Series 90 75cc

Variable Displacement Pump

Service bulletin

SB-1993-015

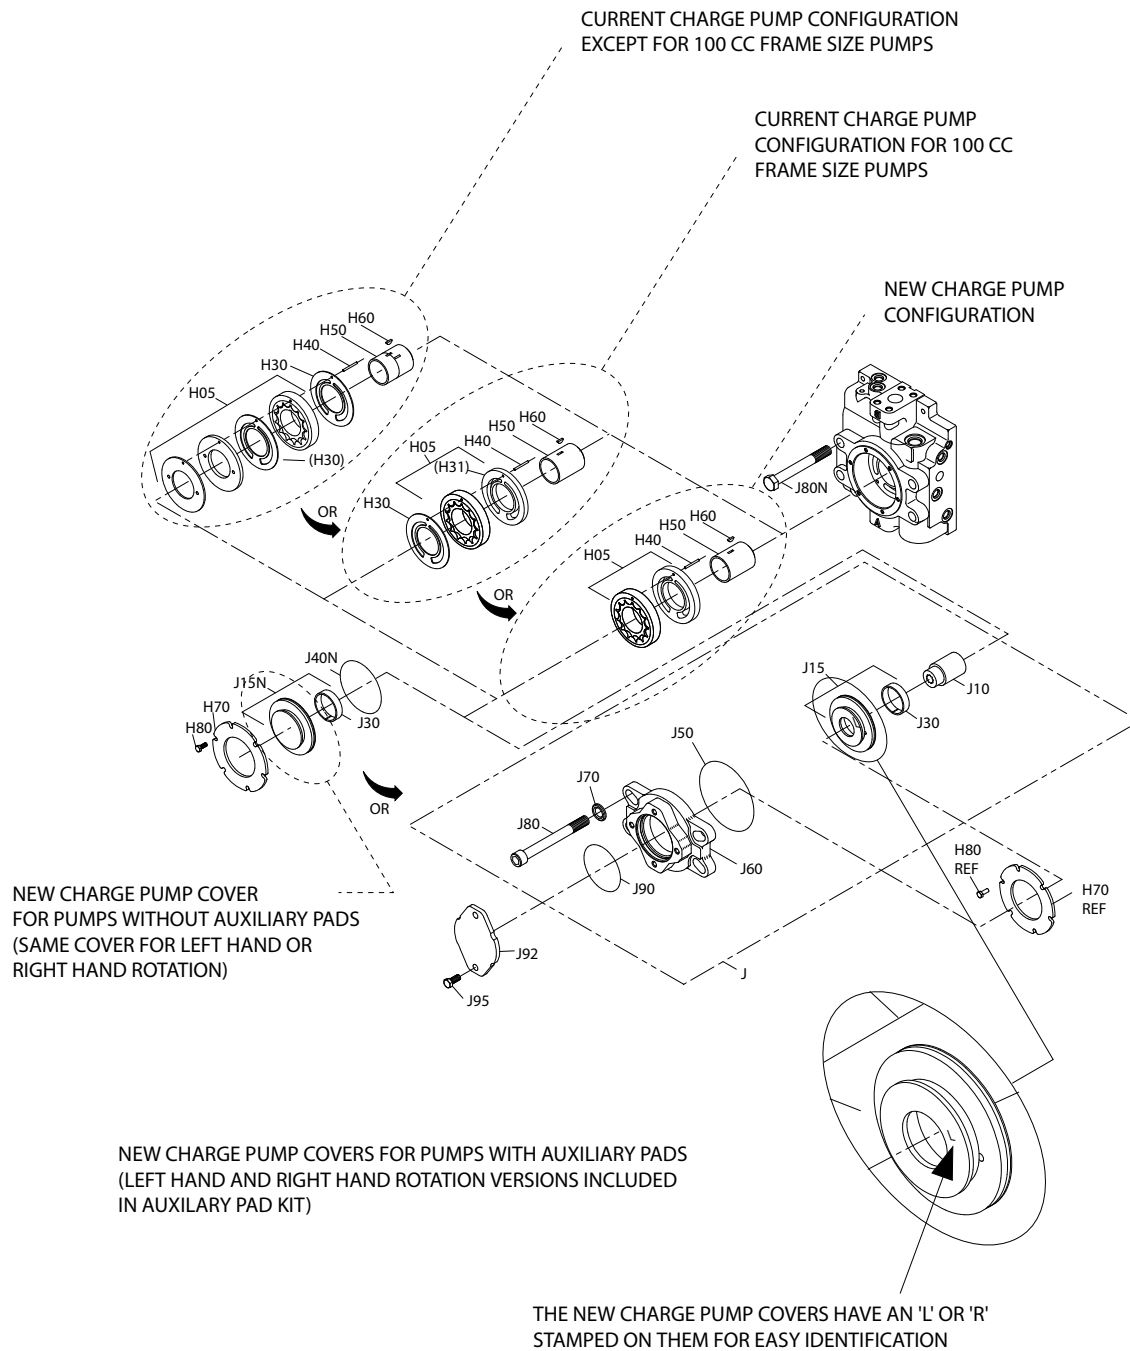
Interchangeable for s/n 89-17-xxxxx and beyond. Piece parts are not interchangeable.
